Selwyn District Council
CONSENT APPLICATION 2225180
KEA-X SOLAR FARM, BROOKSIDE
LANDSCAPE REVIEW

18Sept2022

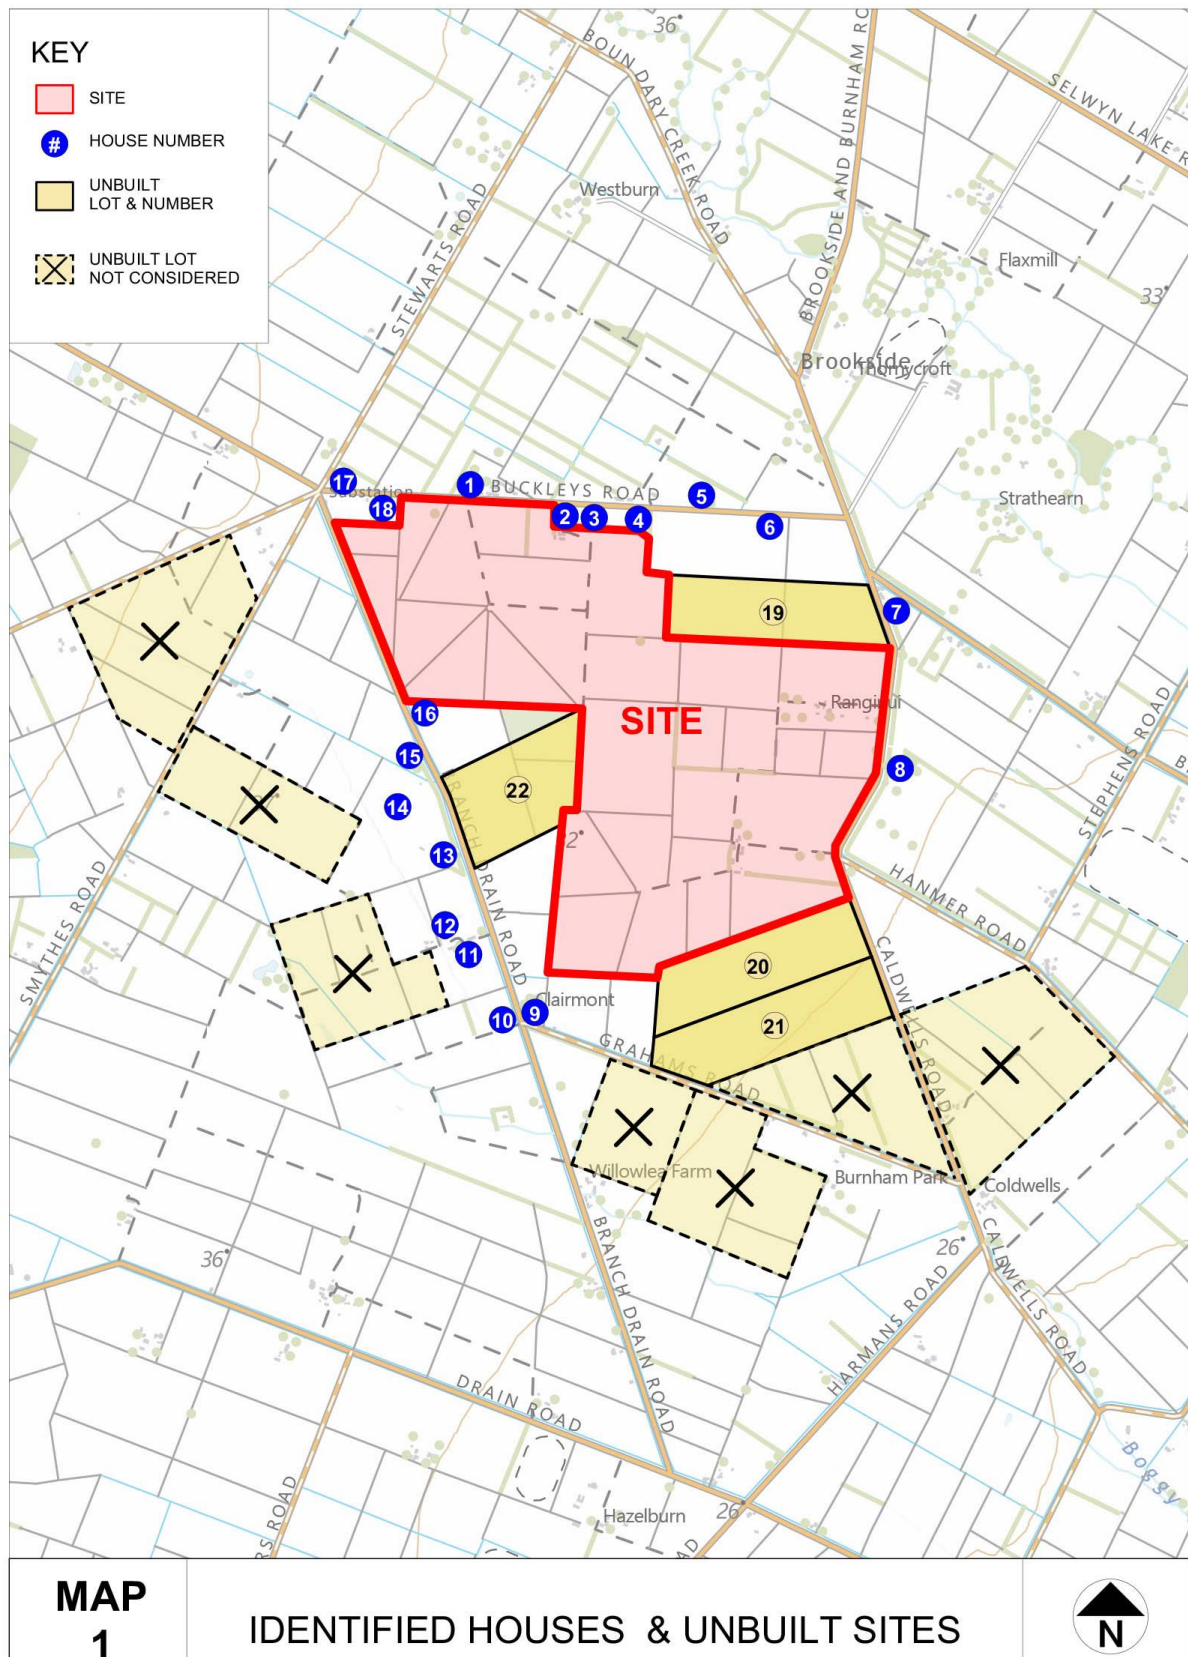
This definition of the visual catchment is **accepted** although as stated, several unbuilt lots will also be considered.

31. In addition to the above four unbuilt properties, a further nine over 20ha exist in the wider locality south and west of the application site. However, these are judged to be sufficiently removed from the site as to be not affected. They are marked on Map 1 but will not be considered further.

These are shown on Map 1. Seven other sites, also over 20ha but not considered likely to be affected by the solar farm, also are marked with a cross on Map 1.
